SERVICE BULLETIN NO. 55

SUBJECT: Slide Rail Cleat Guide

MODEL AFFECTED: 1971 Mustang with Power Slide

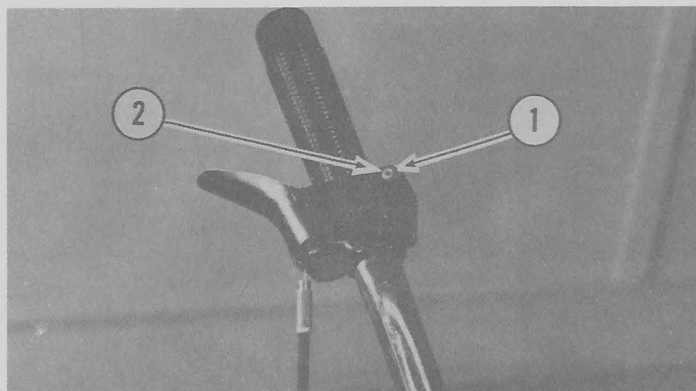
On some early production machines the pop rivets in the plastic blocks which hold the brake handle, may be protruding somewhat from the plastic.

Using the pop rivet hole as a guide, a No. .158 drill should be used to drill the rivets out. Then insert the long solid rivet purchased under Part No. 7661609. Then the end of the rivet should be flared by tapping lightly.

1. Drill pop rivet here
with No. .158 drill
2. Also install longer solid rivet here
where original rivet was located
3. After flaring the solid pin,
make sure the control works freely

CAUTION: Tap lightly to prevent binding of the rivet in the plastic block. The lever must work freely!

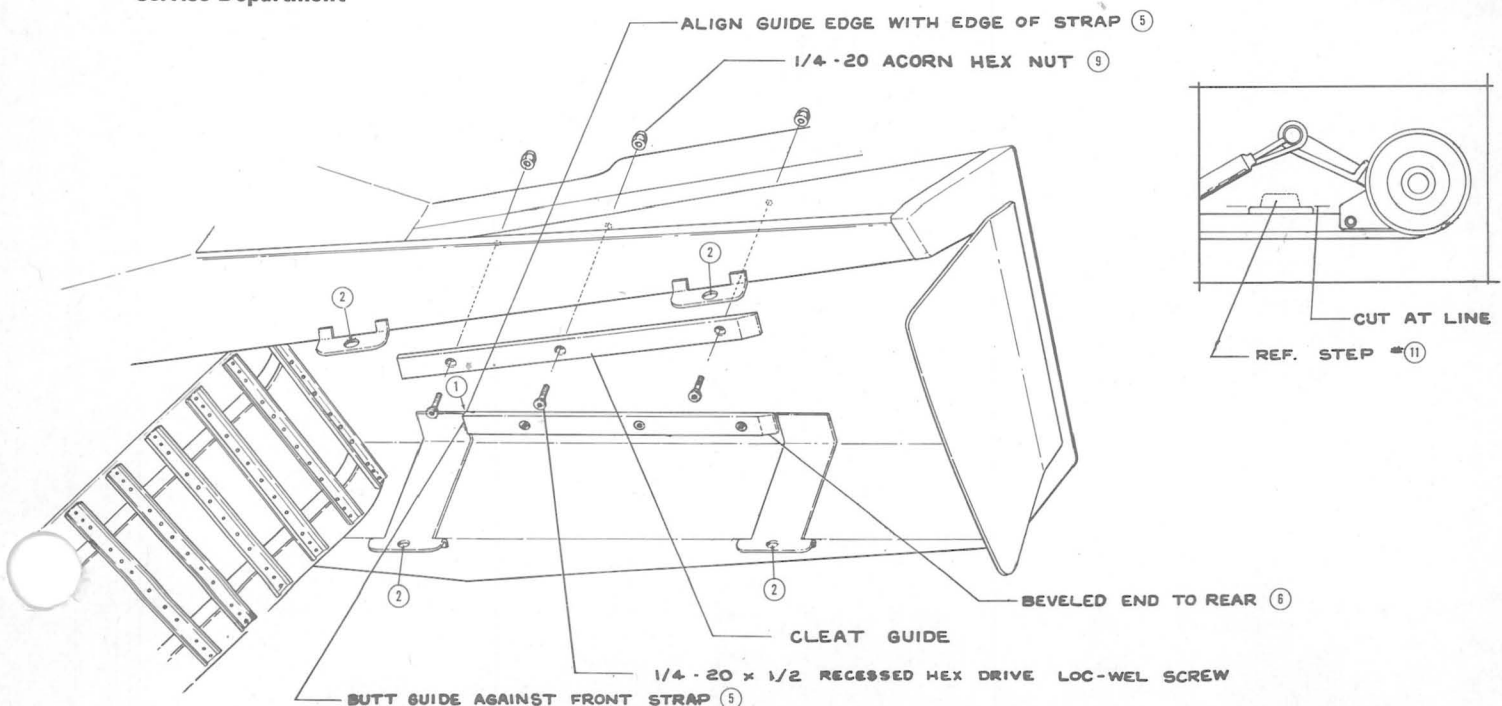
- 3.) Lift the rear end of the unit approximately three (3) feet and let the track and suspension hang down.
- 4.) Make sure that the top end of the reinforcing straps lay flat against the top of the tunnel body. If not, flatten against the tunnel with a hammer. Do not allow any portion of the reinforcing bracket to hang below the cleat guide. See Diagram Circle No. 1.

- 5.) Butt the cleat guide against the front tunnel reinforcing strap, as per Diagram, making sure the inside edge of the cleat guide is aligned with the top end of the reinforcement straps both front and rear.

- 6.) Make sure the beveled end of the guide is toward the rear of the machine.
- 7.) Drill three (3) one-fourth (1/4) inch holes through the tunnel, using the cleat guide as a reference for the hole location.

- 10.) Repeat steps No. 4 through 8 on the other side of the tunnel.
- 11.) To better the ride of this suspension, cut both rear rubber pads off even with the base of the pad. See insert Diagram.

SUBJECT: Return Gas Line

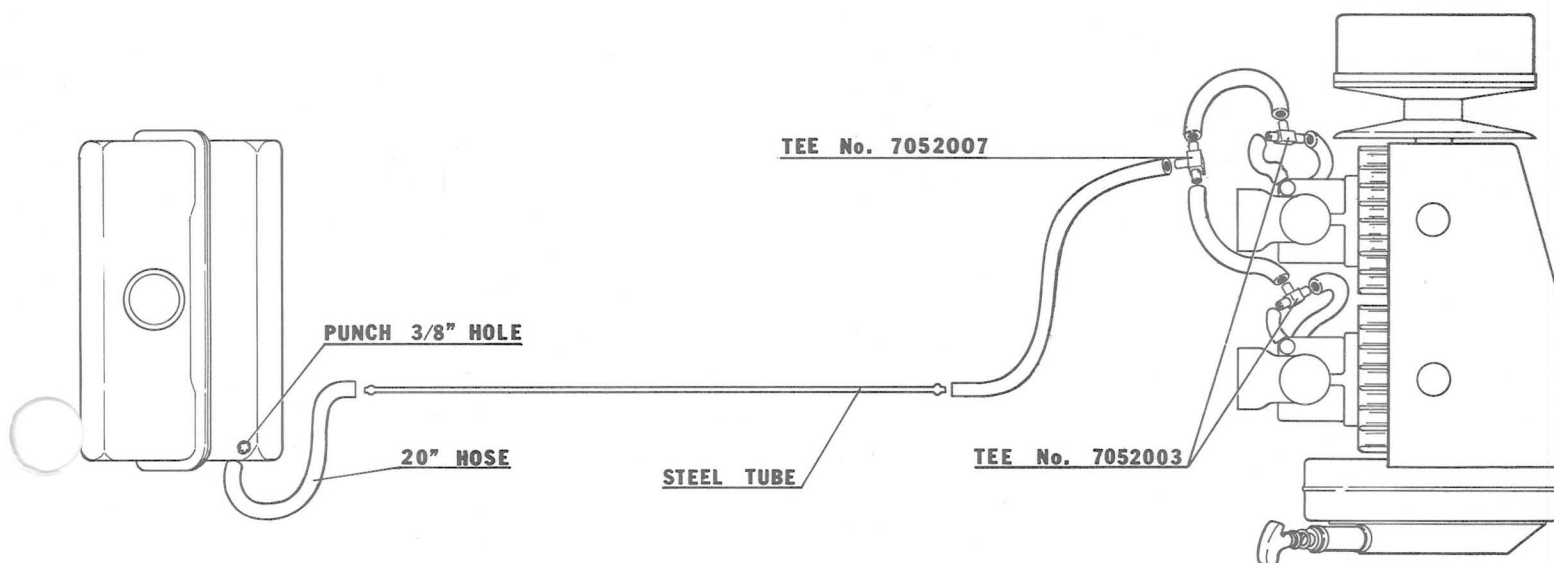
12. Pour the gas from the tank into a container.
13. Place the gas tank on a clean work bench. (Be sure the cap is off the tank.)
14. **CAUTION:** Carefully read Steps 15 and 16 before you proceed. (Also see print.)

15. In the upper left hand corner, punch a 3/8 " hole. You must use a sharp pointed punch. (The tank must be sitting, so that the hose you pinched shut in Step 9 is towards you.) Do not drill this hole, punch it.

16. Extreme care must be used; the hole must be the size specified, so the hose will fit tightly in the hole.
17. Once the hole has been punched, insert the rubber hose, (part no. 5420077), and push it approximately four (4) inches into the tank. (This hose is 20 " long.)

SUBJECT: Venting of Gas Caps

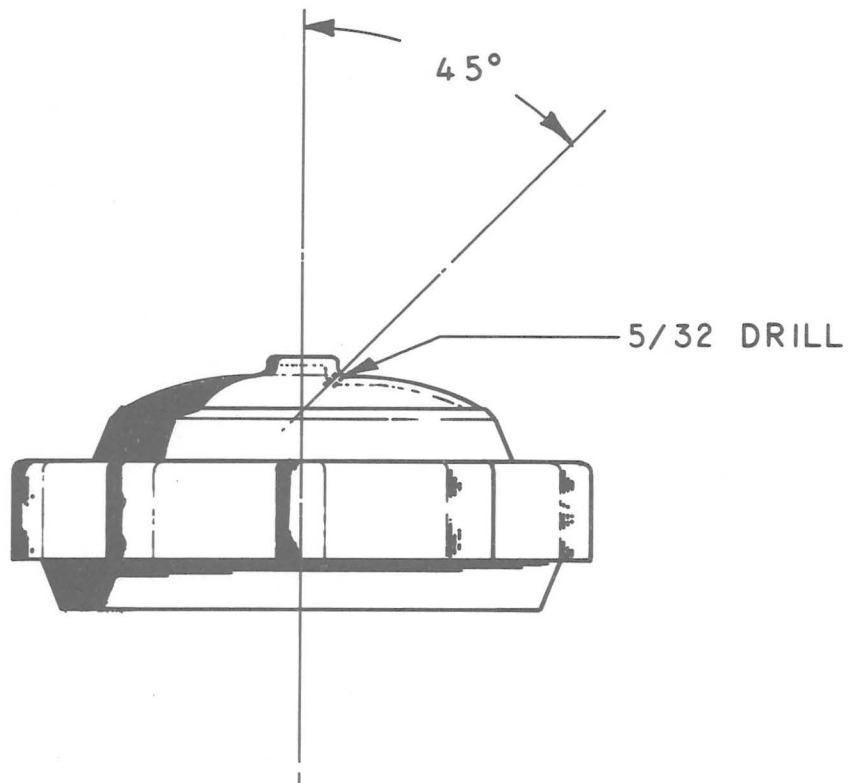
Reason: To eliminate the possibility of a lean fuel/air mixture caused by partially blocked vent tube on the steel gas tank.

Procedure: Drill a vent hole 5/32 through the clear plastic part of the gas cap.

SUBJECT: Installation of Guard for Adjustment Bolt

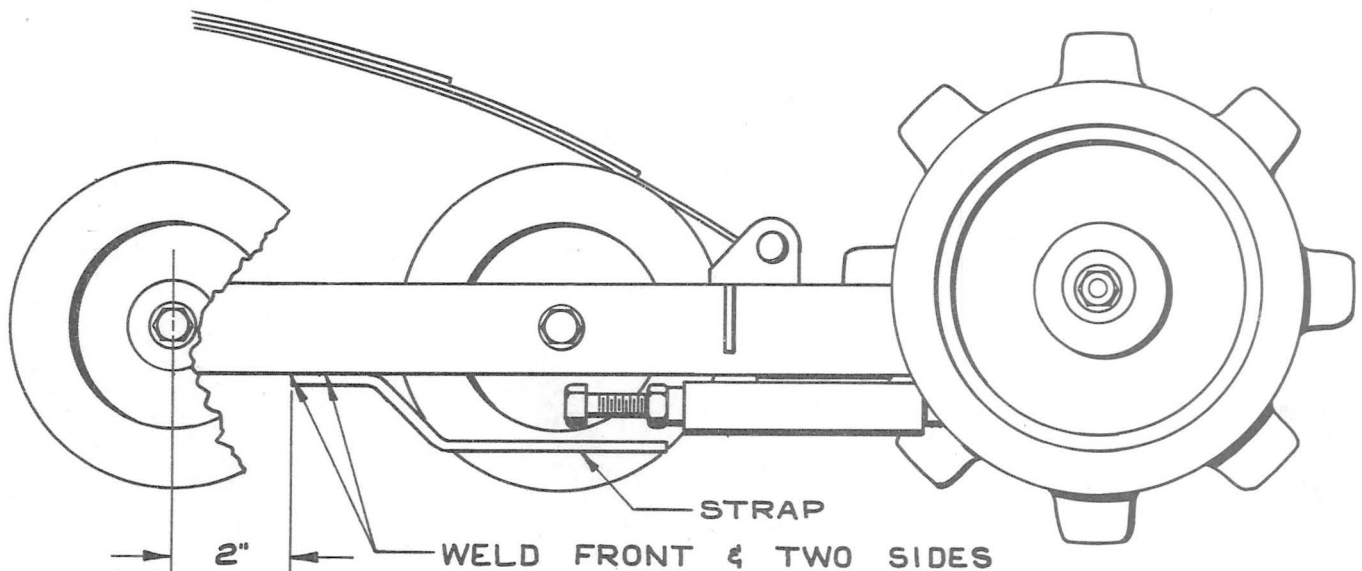
REASON: To eliminate possible damage to the track should it hit a small hard object directly on the adjustment bolt.

1. Tip the entire unit over on its side.
2. Place the guard in agreement with specifications called out in the print and weld it in.
3. Tip the unit over on the other side and repeat the procedure.

No. 1540352

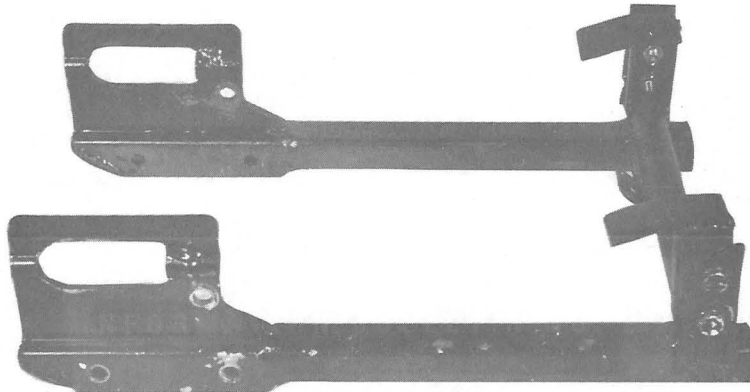
Rear Hanger Assembly — Part Number 1540352 is now available as a replacement part for the Playmate Power Slide.

This replaces Part Numbers — 1540301 — Rear Hanger Assembly and Part Number — 1540292 — Tube and Spring Adjuster Assembly.

Figure 1

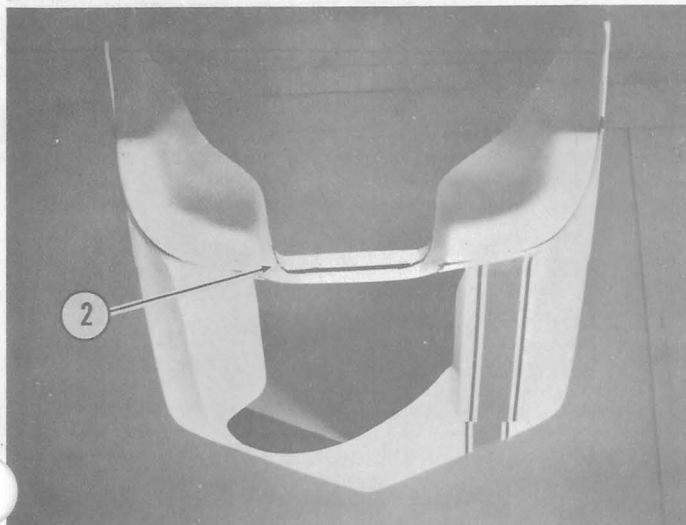
- 1.) Remove Jiffy trim from hood. See No. 1 in Figure 2.
- 2.) Draw a line as pictured in No. 2 in Figure 1, to indicate the portion of fiberglass to be removed. This line should be drawn within one-half (1/2) inch from radius. By so doing, the strip removed should be approximately one (1) inch in width, and will achieve a better throttle radius. The fiberglass may be cut with a hack saw.
- 3.) Place Jiffy trim back on hood.
- 4.) After this operation, the carburetor and cables should appear as shown in No. 3 in Figure 2.

Fig. No. 1

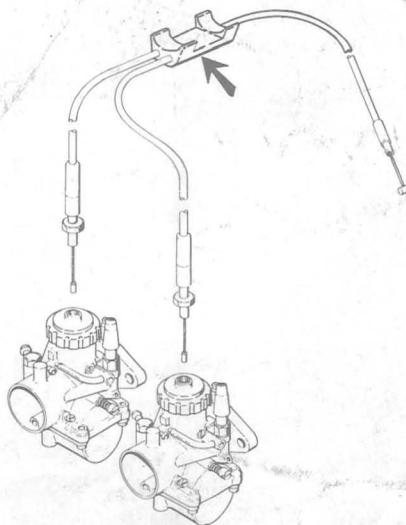
Due to the recent problem encountered with failure of the throttle cable junction block (fig. no. 1), the following policy is being adopted:

ALL 1970 Polaris machines equipped with the throttle cable shown in fig. no. 1 must be replaced.

Fig. No. 2

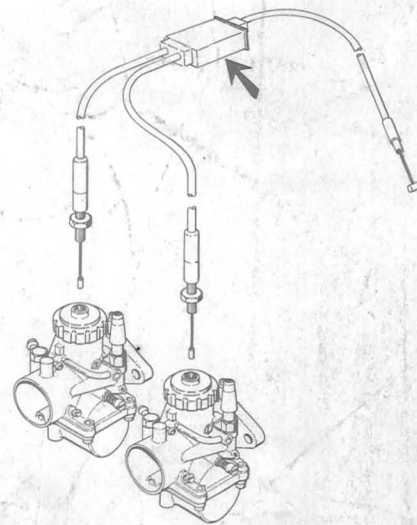
In order to accomplish this program, it will be necessary to install the new throttle cable (fig. no. 2) on machines that fall into three categories.

The modified throttle cable (fig. no. 2) will be controlled under the same part number as the original parts, which they fully supersede: part no. 2050001.

Following installation of the throttle cable, an operating check should be made. The throttle should operate smoothly, and the slide should drop back to its stop without hesitation when the throttle is released. When the throttle is depressed the slides should begin to lift at exactly the same time. If there is any evidence of sticking, do not attempt to start the engine until it has been corrected.
